ADDENDUM #01

ADA Compliance Upgrades Foussat and Libby

BID NO. 2025-21-070B

RFI #1: DWG Review - ADA Scope

- CONTRACTOR TO FIELD VERIFY EXACT LOCATION AND ELEVATION OF EXISTING GRADES, SITE IMPROVEMENTS AND UTILITIES PRIOR TO CONSTRUCTION. IF ANY CONFLICTS OR DEVIATIONS FROM THIS PLAN ARE IDENTIFIED, THE CONTRACTOR SHALL NOTIFY AND COORDINATE WITH THE ENGINEER OF WORK PRIOR TO CONSTRUCTION.

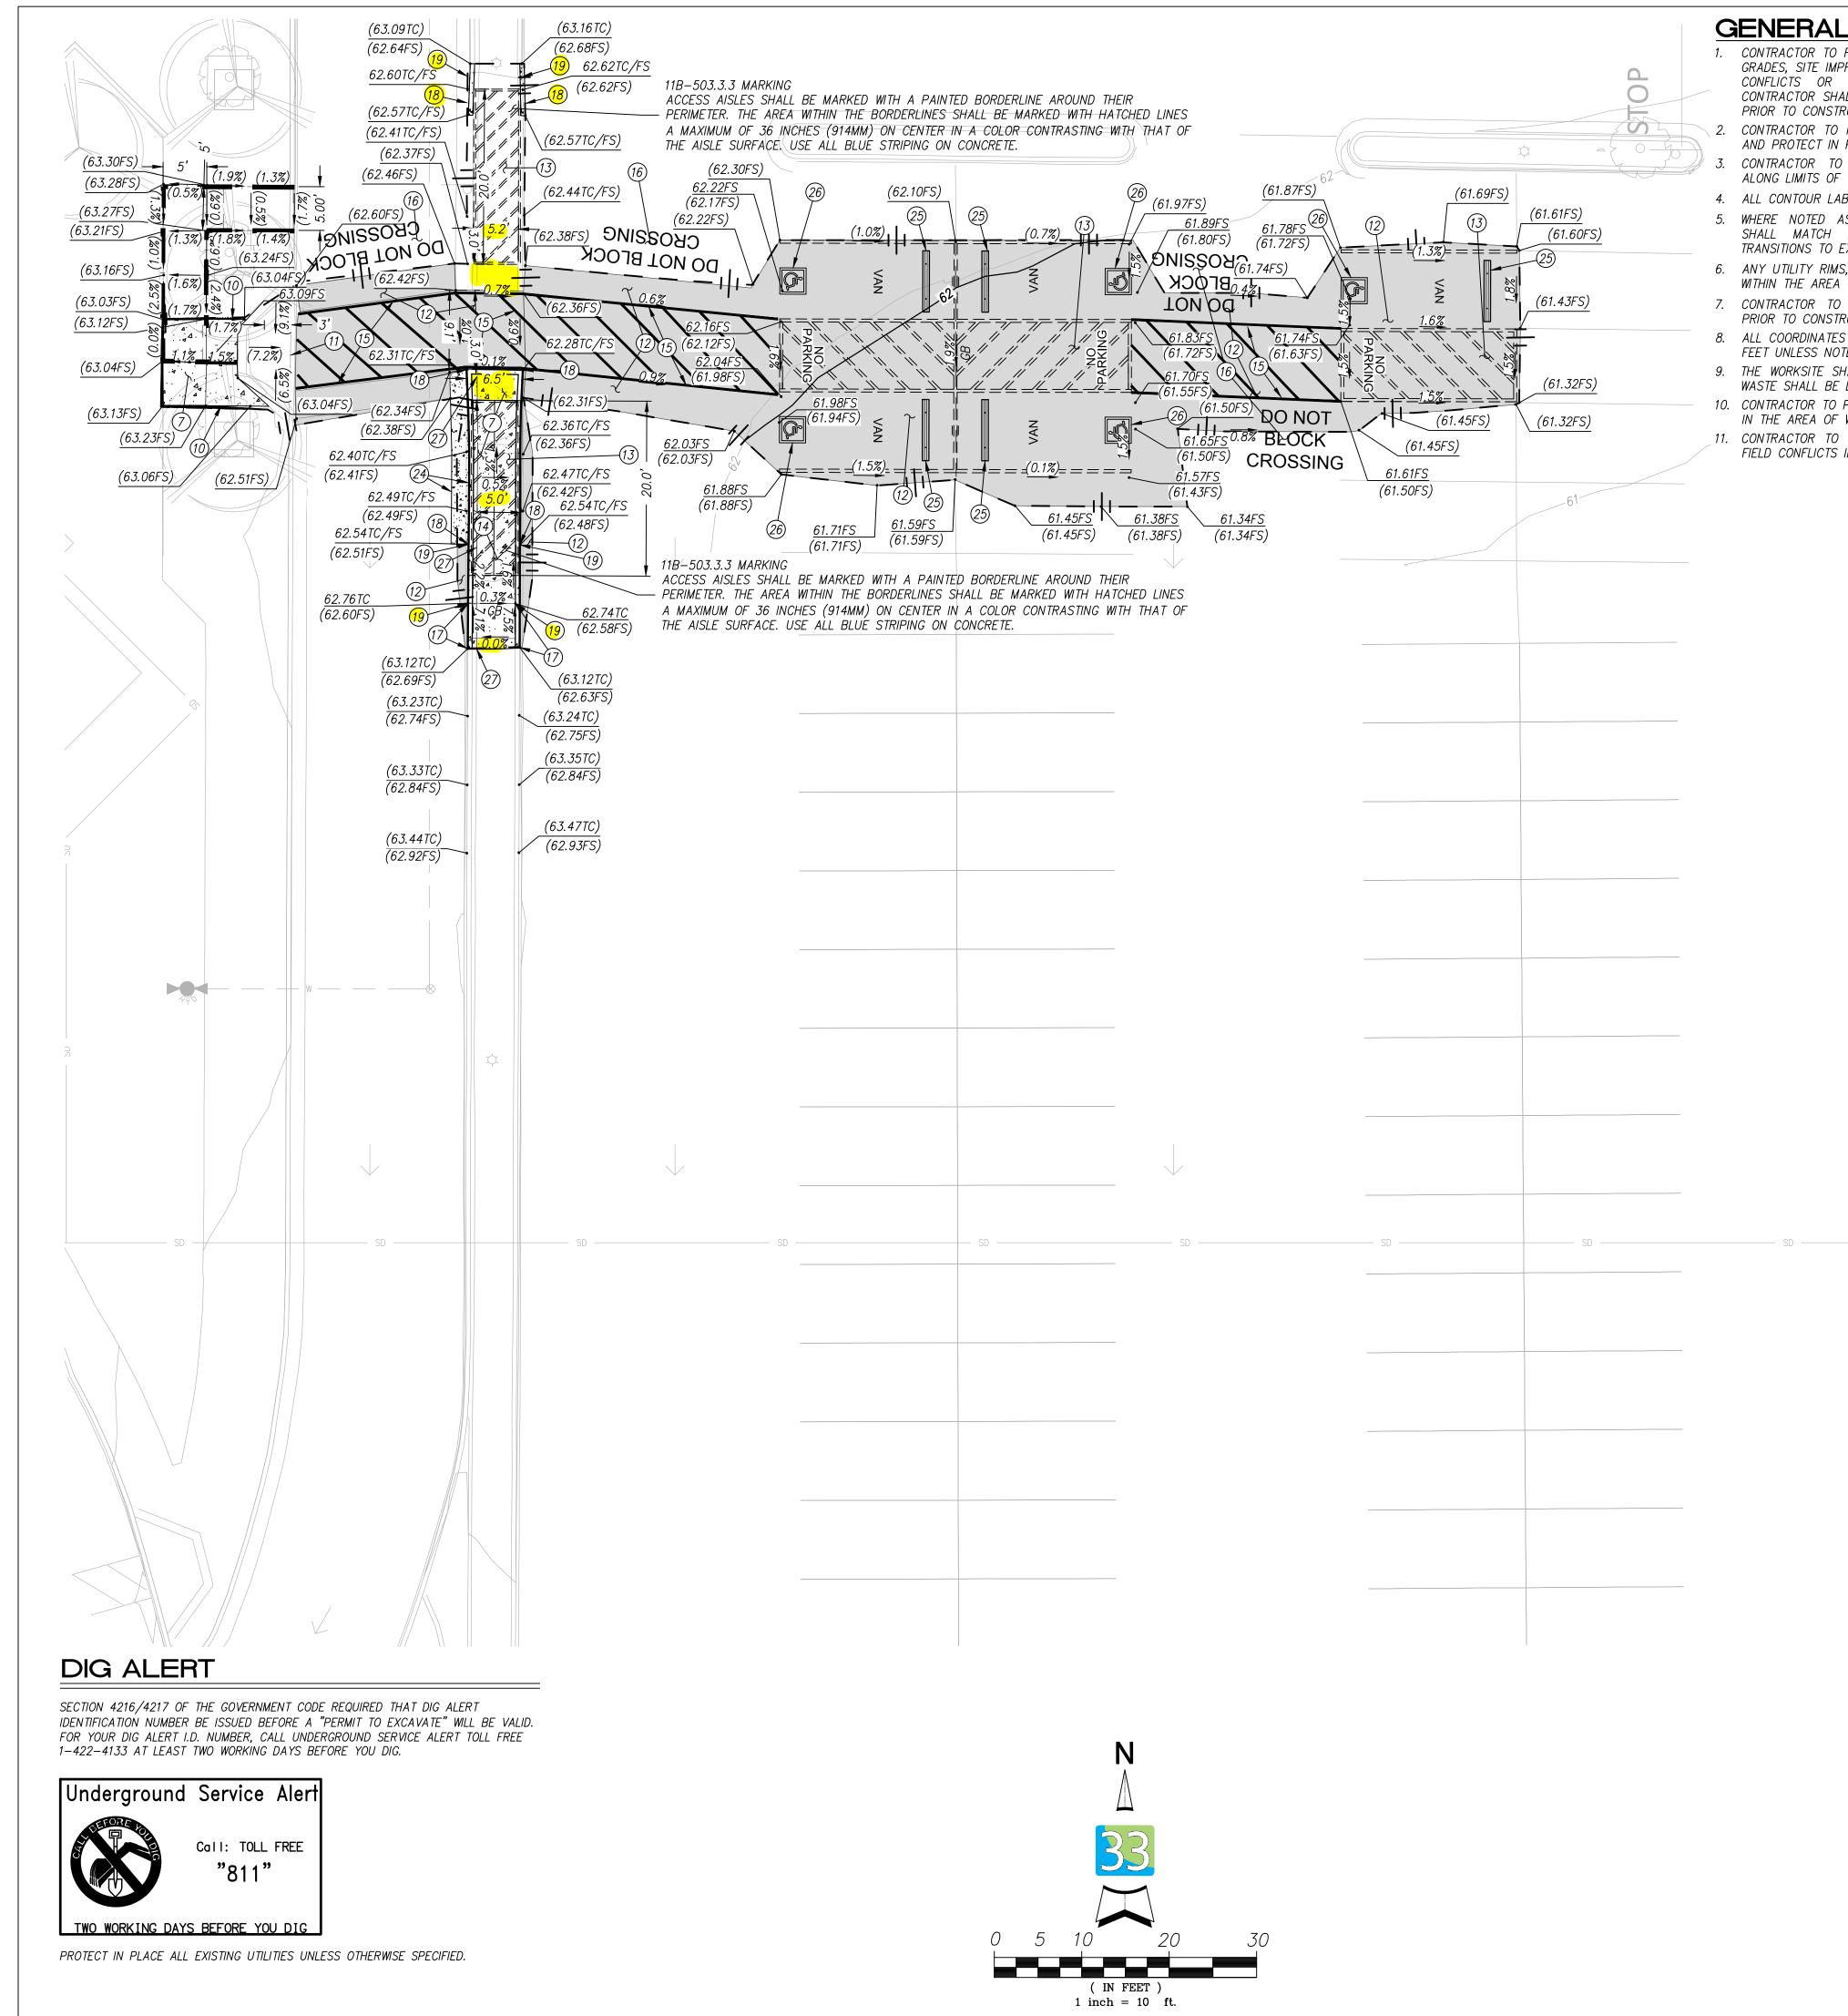
Sheet - C1.4 is now C1.2: I have some dimensions and highlights for the areas in question.

- The images show that we do not have 5' of sidewalk on either side of the sidewalk due to the existing fence. Please clarify if 5' is a minimum requirement for the sidewalk. (This will help me determine the scope needed for the existing fence at both sides.) DSA instructed us that the dimension of the sidewalk is from inside face of fence to outside face of curb (we can include the curb in the dimension!) so I think we are ok.

- 2. There appears to be a space between where the truncated domes were needed vs where the sidewalk striping starts. Please clarify if there is a minimum amount of spacing between the asphalt striping and sidewalk striping. You will see that one of the sidewalks already has striping that is 20' but that is dependent on the existing spacing shown. Please note, if there is a clearance requirement to obtain the 20', I may run into conflicts with the existing light post. The plans contemplate removal and replacement of portion of the curb and place a transition curb on the north side drop off, which will in fact be close to the light post.

- 3. Please clarify if you want the opposite side of the pathway that does not have striping to mirror the sidewalk that already has striping. I have 3 options available on

the attached C1.4 AKA C1.2 for your input. If I am understanding correctly, the sidewalk, curb, and painting should mirror the existing side.

C1.4

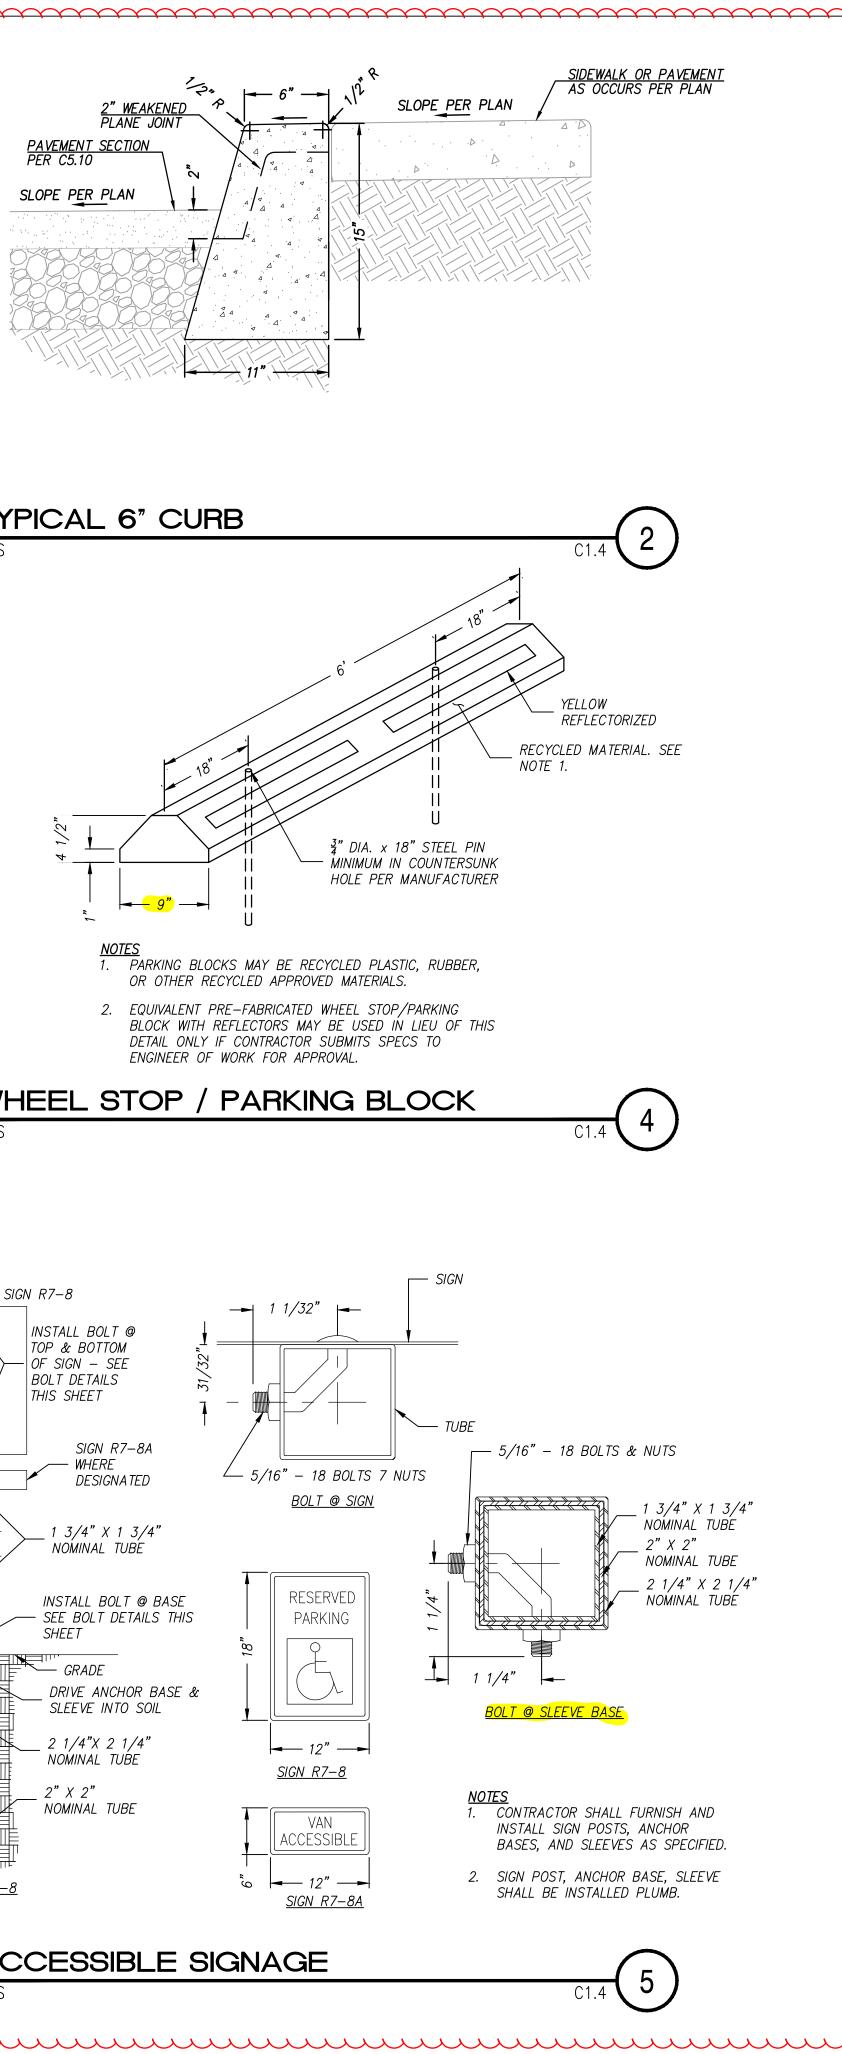
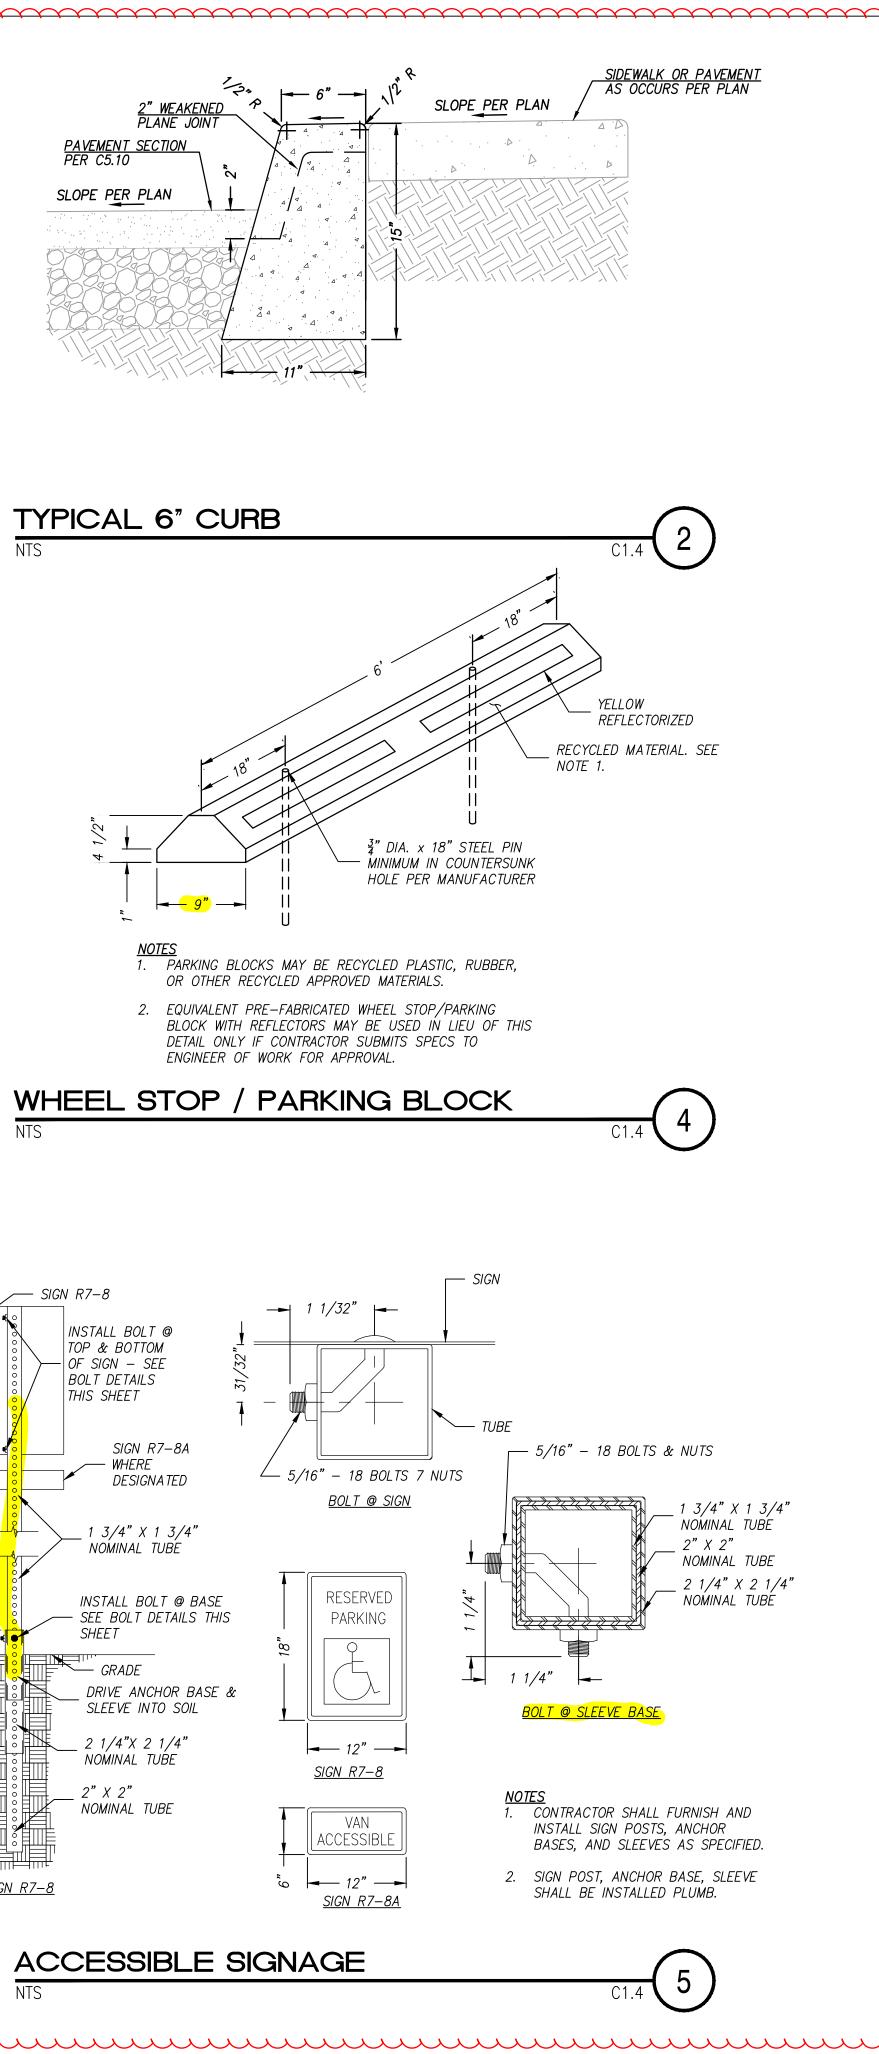
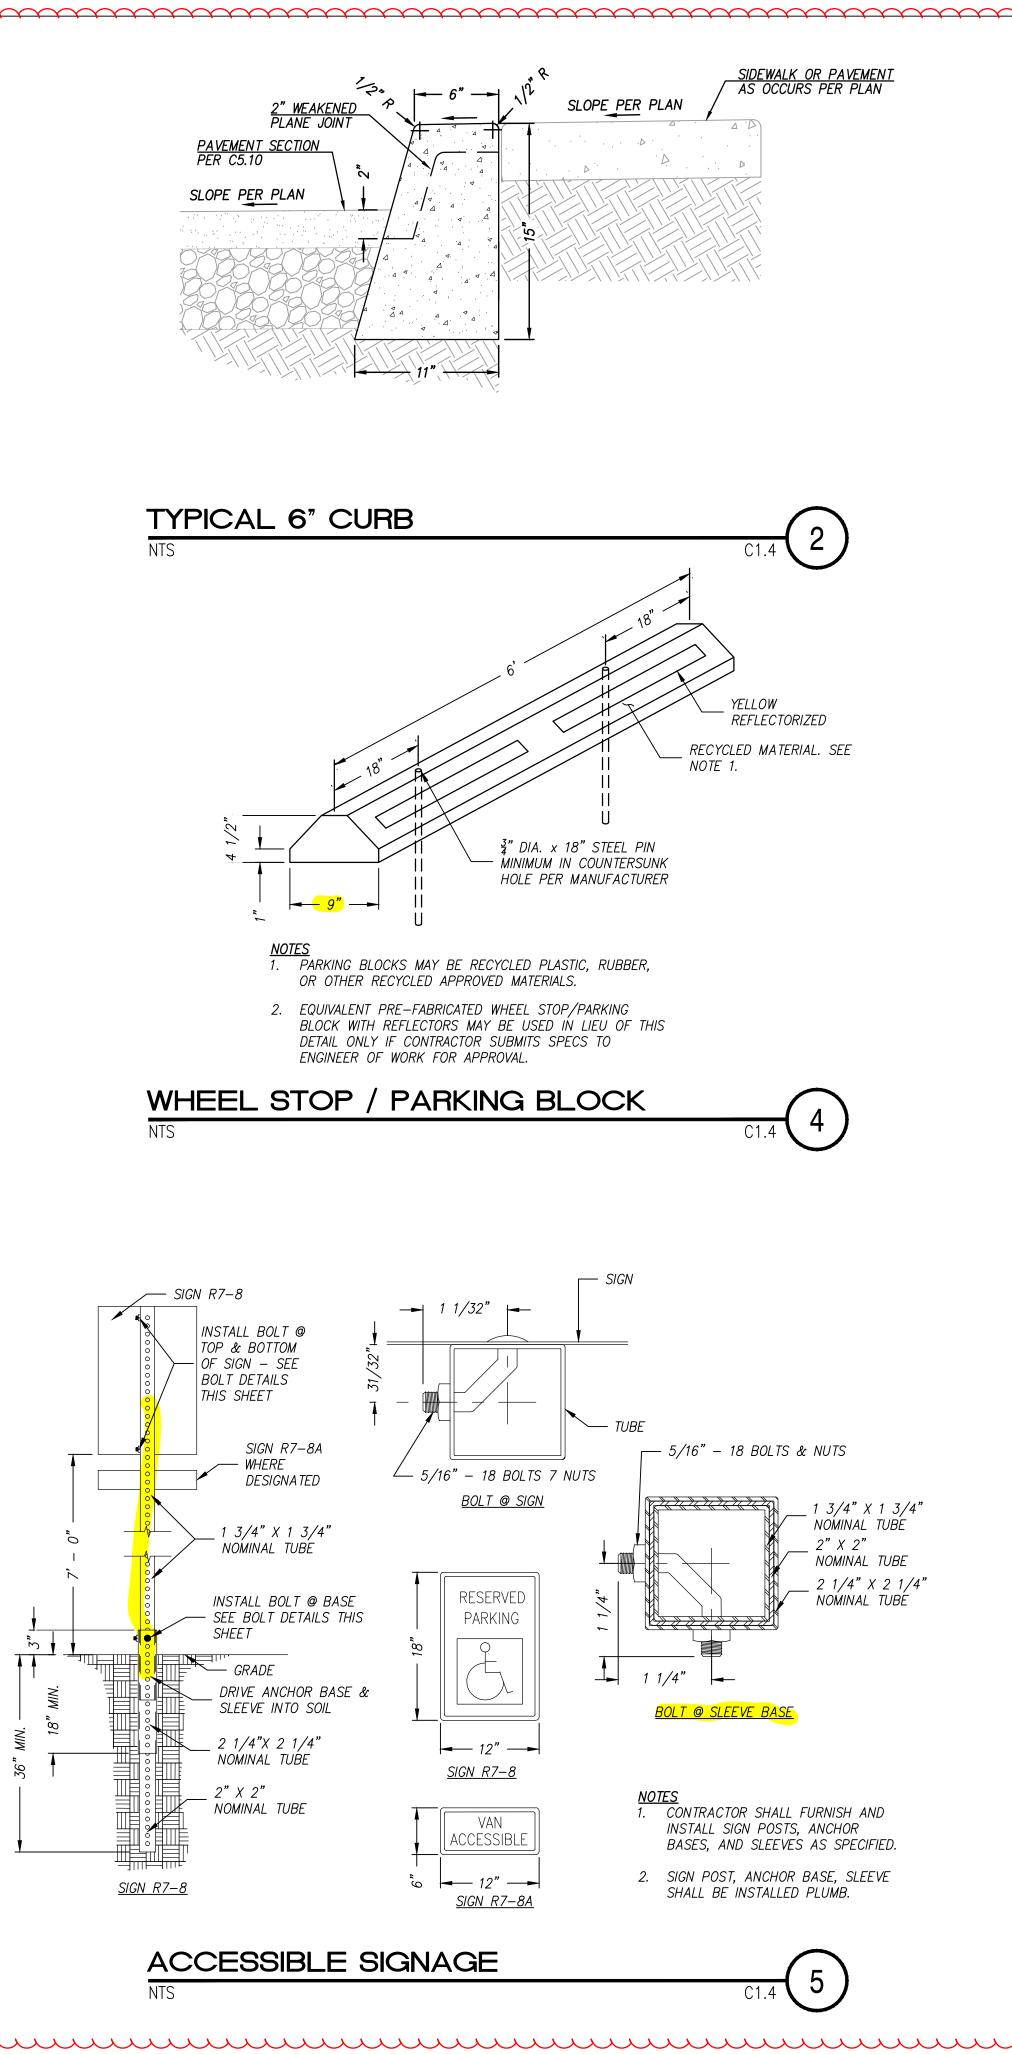
Sheet - C1.6 - Some more existing conditions Questions:
	 Detail 4 - Please confirm it is acceptable that the existing wheel stops are 7" not 9". Detail 5 - Please clarify if it is acceptable, we keep the existing parking sign poles, since we are not planning to need to cut up the parking lot. Detail 5 - I have images of how the existing poles have multiple signs attached to them. If we can keep the poles, please let me know if it is acceptable we use the existing application to install multiple signs on the poles.
	Attachments C1.6 ADA Details MU.pdf, C1.1_ DEMOLITION PLAN Rev.V3 MU.pdf, C1.5_ ADA DETAILS Rev.V3 MU.pdf, C1.4_ FOUSSAT LOT PRECISE GRADING Rev.V3 MU.pdf
Official Response	Response from Corrisa Bolls MAAS on Wednesday, Apr 9, 2025 at 01:17 PM PDT
	Civil Engineer Latitude 33 clarifications attached.
	Attachments 2025_0130_Foussat General Qs_Maas-L33 Responses.pdf
All Replies	Response from Corrisa Bolls MAAS on Wednesday, Apr 9, 2025 at 01:17 PM PDT

- Detail 4 Please confirm it is acceptable that the existing wheel stops are 7" not 9". No.
- 2. Detail 5 Please clarify if it is acceptable, we keep the existing parking sign poles, since we are not planning to need to cut up the parking lot. Yes, assuming they meet the standard in these drawings.
- 3. Detail 5 I have images of how the existing poles have multiple signs attached to them. If we can keep the poles, please let me know if it is acceptable we use the existing application to install multiple signs on the poles. This is per civil, and these two questions are tied together. The detail allows for attachment of the two required signs for these spaces, Reserved parking and Van Accessible. Signs should be installed with dimensions of details at heights indicated in the detail.
